World Forum for Harmonization of Vehicle Regulations**Working Party on Noise****Fifty-sixth session**

Collective amendments—Regulation Nos. 9 and 63**Proposal for the 07 series of amendments to Regulation No. 9
(Uniform provisions concerning the approval of category L₂,
L₄ and L₅ vehicles with regard to noise)****Submitted by the experts of the International Motorcycle
Manufacturers Association ***

Regulation No. 9

Figure 1
Positions for testing the vehicle in motion

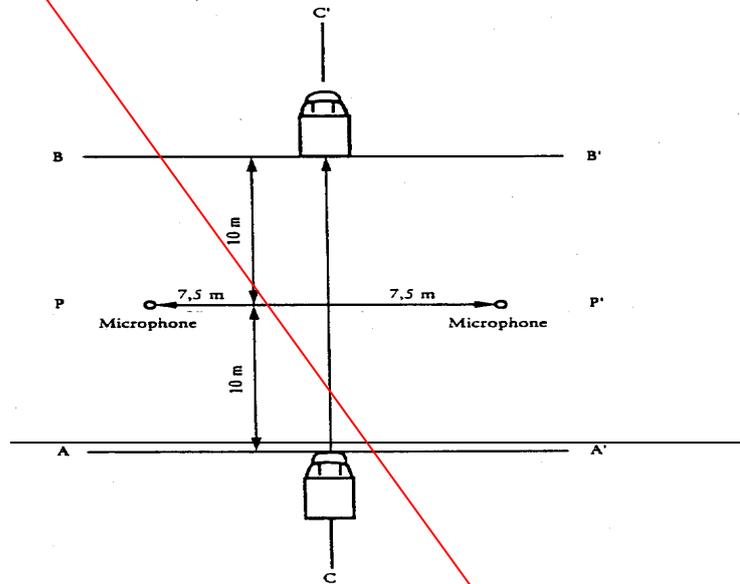
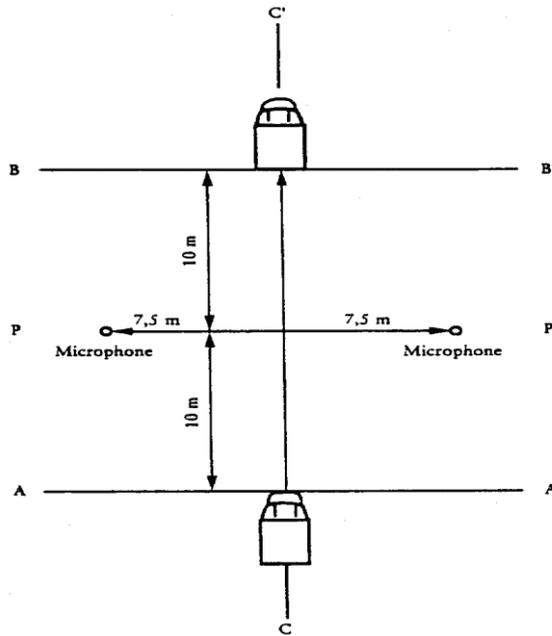
The distance of the microphone positions from the line CC', on the microphone line PP', perpendicular to the reference line CC' on the test track (Figure 1), shall be 7.5 \pm 0.05 m.

The microphones shall be located 1.2 \pm 0.02 m above the ground level. The reference direction for free-field conditions (see IEC 61672-1:2002) shall be horizontal and directed perpendicularly towards the path of the vehicle line CC'.

Figure 2
Positions for testing the stationary vehicle

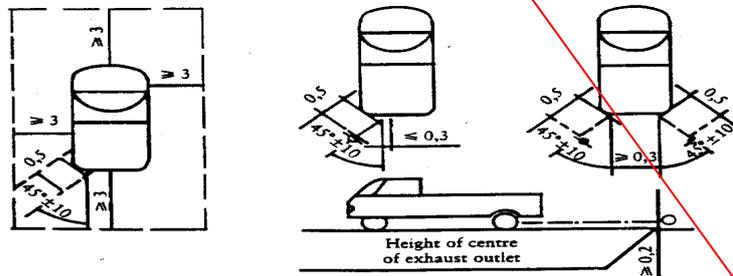
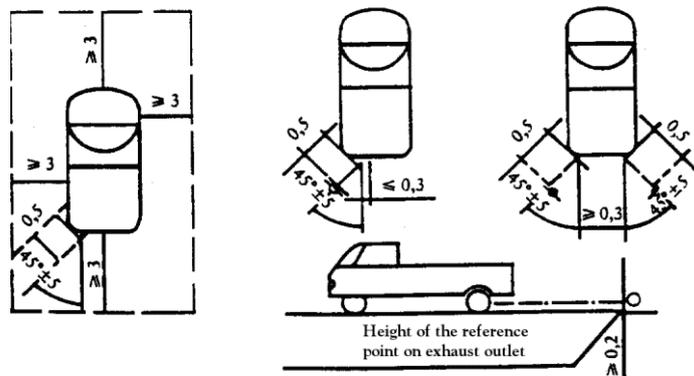
3.2.4.2. ~~Position of the microphone~~ **Positioning of the microphone (see Figure 2)**

The microphone shall be located at a distance of 0.5 ± 0.01 m from the reference point of the exhaust pipe defined in Figure 4 and at an angle of $45 \pm 5^\circ$ to the vertical plane containing the flow axis of the pipe termination. The microphone shall be at the height of the reference point, but not less than 0.2 m from the ground surface. The reference axis of the microphone shall lie in a plane parallel to the ground surface and shall be directed towards the reference point on the exhaust outlet.

Figure 4
Reference point

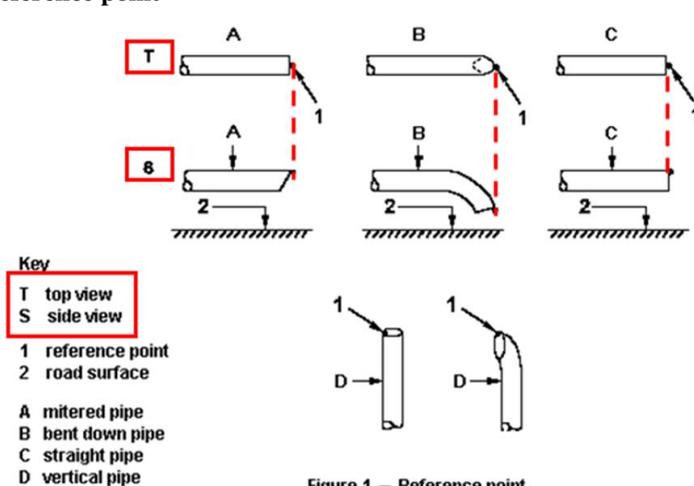
The reference point shall be the highest point satisfying the following conditions:

- (a) **The reference point shall be at the end of the exhaust pipe,**
- (b) **The reference point shall be on the vertical plane containing the exhaust outlet centre and the flow axis of the exhaust pipe termination.**
